Joint Regional Planning Panel (Sydney East Region)

JRPP No.	2014SYE103
DA No.	DA/320/2013/A
Local Government area	Randwick City Council
Proposed Development	Section 96 modification of the approved development through basement car park alterations allowing increase to 283 vehicle spaces, changes to retaining walls within the eastern boundary setback, reconfigure ground floor retail to allow for 4 tenancies, increase number of approved units from 100 to 113, reconfigure apartment layouts and increase roof height Original consent: Demolition of the existing buildings and construction of a new part 6 and part 7 storey mixed use development comprising of ground floor retail space, 100 residential dwellings, 3 basement levels of parking, associated site and landscaped works
Street Address	84 - 108 Anzac Parade, Kensington
Applicant	Luxcon 88 Pty Ltd
Owner	Luxcon 88 Pty Ltd
Number of Submissions	10
Recommendation	Approval
Report By	Kerry Kyriacou, DA Manager

1. Executive Summary

Figure 2: S96 Proposal

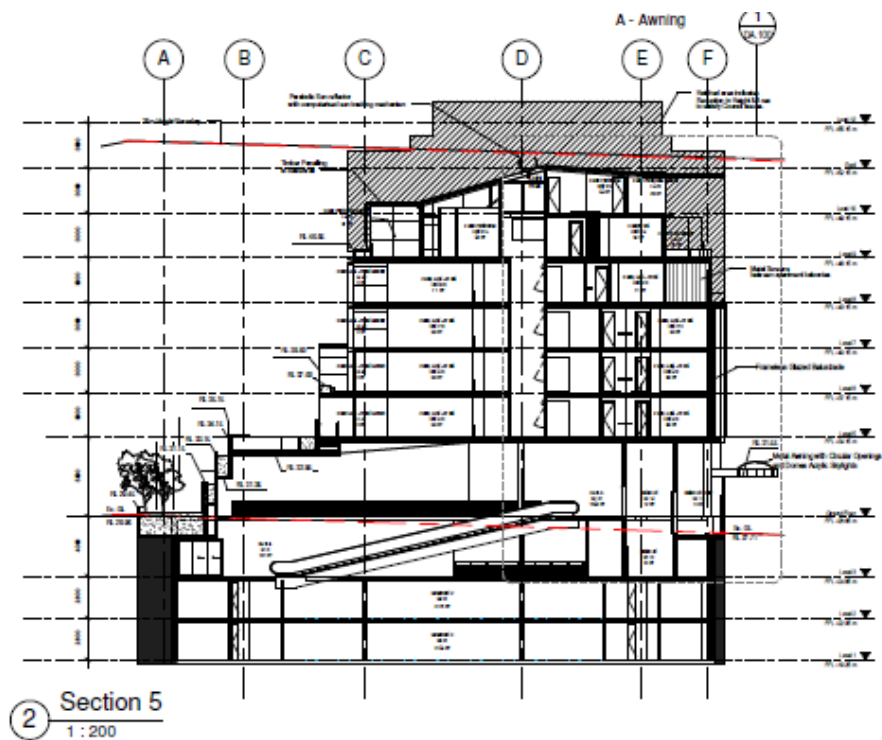
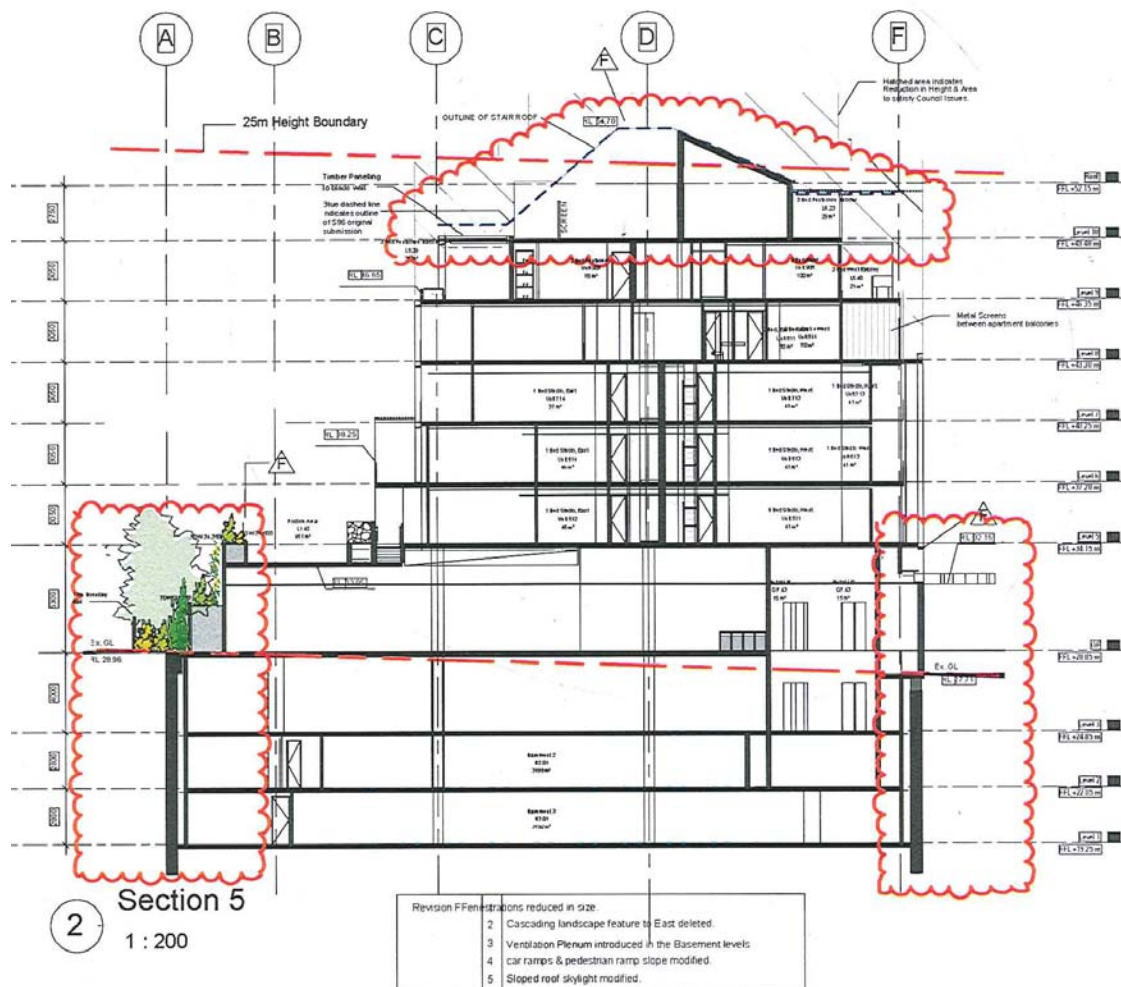
The proposed modification would result in the building being increased in height to a maximum of 27.4m well beyond the maximum height limit of 25m pursuant to RLEP 2012. The increase in the overall height of the building is 2.55m higher than that approved and arises from the amended roof form which has a bulky appearance and awkward shape. The figures below show the new roof form in comparison to that originally approved

Council's Randwick DCP 2013 requires that lift over-runs and service plant are contained within roof structures or roof lines. It also tries to minimise the bulk and mass of roofs and their potential for overshadowing. The proposed roof will compromise the aesthetics of the building by not providing a coherent architectural language and resolution in its overall appearance. The overstated pitched roof form to Anzac Pde and combination of open screening to plant areas to the rear appears piecemeal and does not provide for a cohesive expression of the top of the building or is effective in reducing the visual intrusiveness of the service elements. The screening and location of the plant above apartment 914 would also appear to be excessive and poorly resolved.

- 3(a) *The proposed roof over the northern section of the building (between gridlines 1 & 9) shall be lowered to a maximum RL of 52.82 and shall be redesigned to better integrate with the plant areas to the eastern side of the roof. Details must be submitted to Council's Manager Development Assessment for approval prior to a construction certificate being issued for the proposed development.*

Figure 4: S96 Proposal

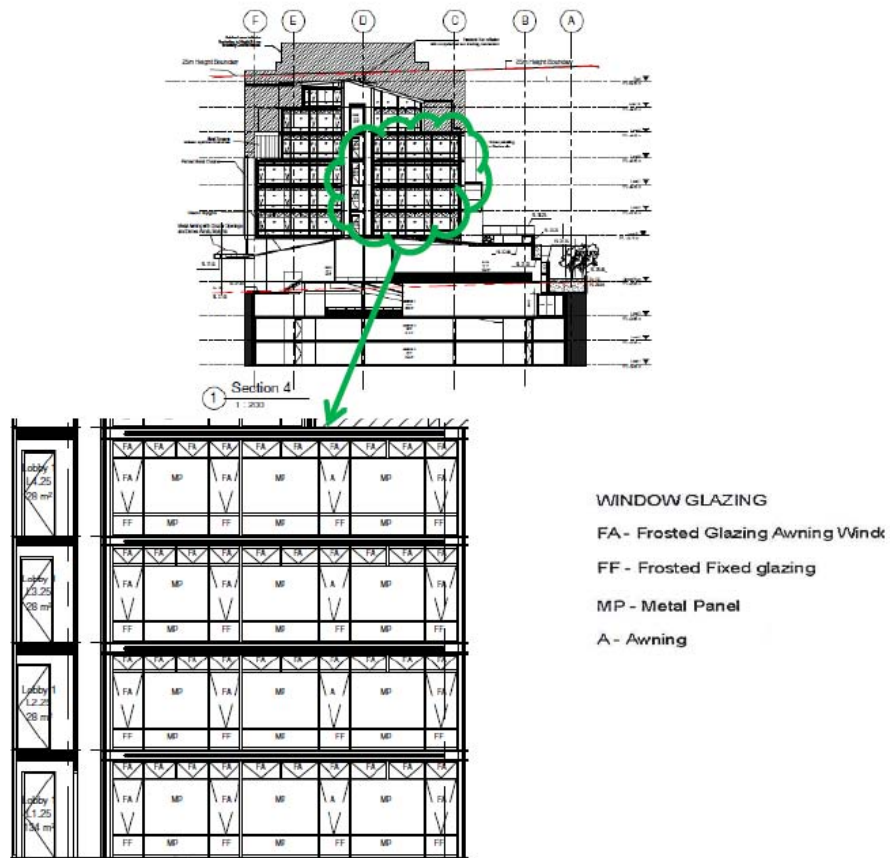
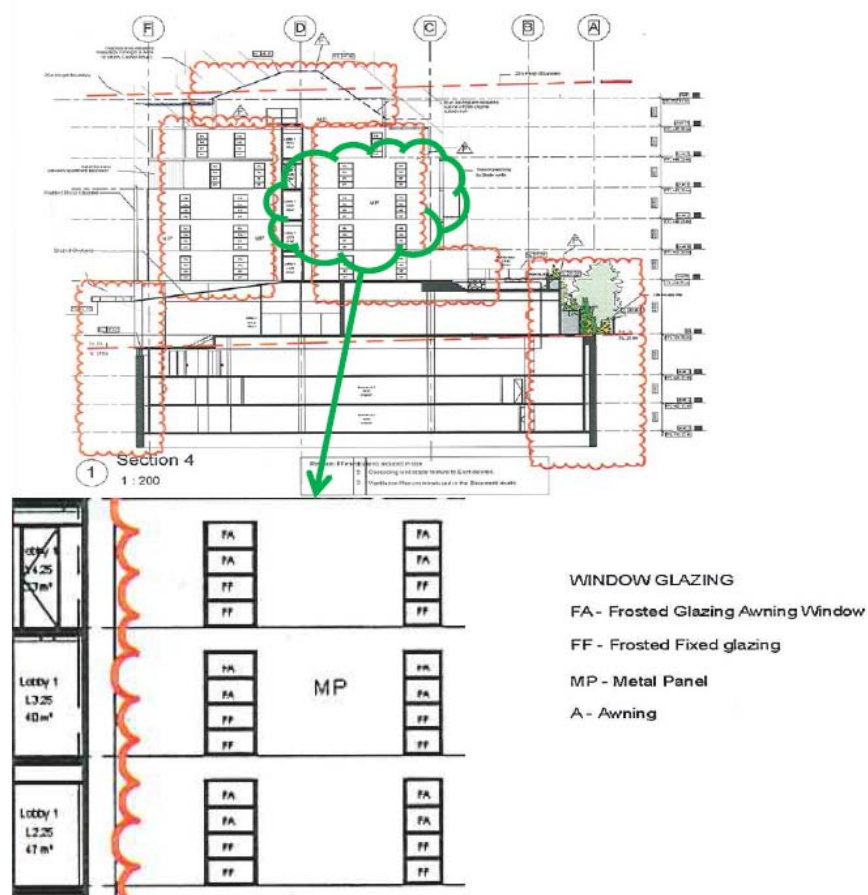
It is proposed to increase the number of apartments within the building from 100 to 113. This has been achieved by reducing the number of cross through apartments and results in the residential floor plates of the building being dominated by a double loaded arrangement. The use of the "slots" to allow for a double loaded arrangement of the floor plate was not considered by Council in the original assessment of the application as being adequate to allow suitable levels of amenity both in terms of light and ventilation to the apartments. Notwithstanding, the JRPP have accepted this approach as an appropriate design solution. I note that the proposed apartment layouts maximise the opportunities for light and ventilation by siting habitable rooms mostly to the external walls. However, the extent of operable glazing to the external walls along the "slots" would appear to be reduced, thereby lessening the ability to provide good levels of light and ventilation (see figures 3 & 4 below). As a significant proportion of the apartments will be reliant on the "slots" for light and ventilation, it is critical that these openings be maximised. A suitable condition is included in the recommendation requiring the amount of operable glazing to be increased consistent with the originally approved plans.

- (c) *The amount of operable glazing to the "slots" shall be increased to be consistent with the plans dated 14 March 2014. Details must be submitted to Council's Manager Development Assessment for approval prior to a construction certificate being issued for the proposed development*
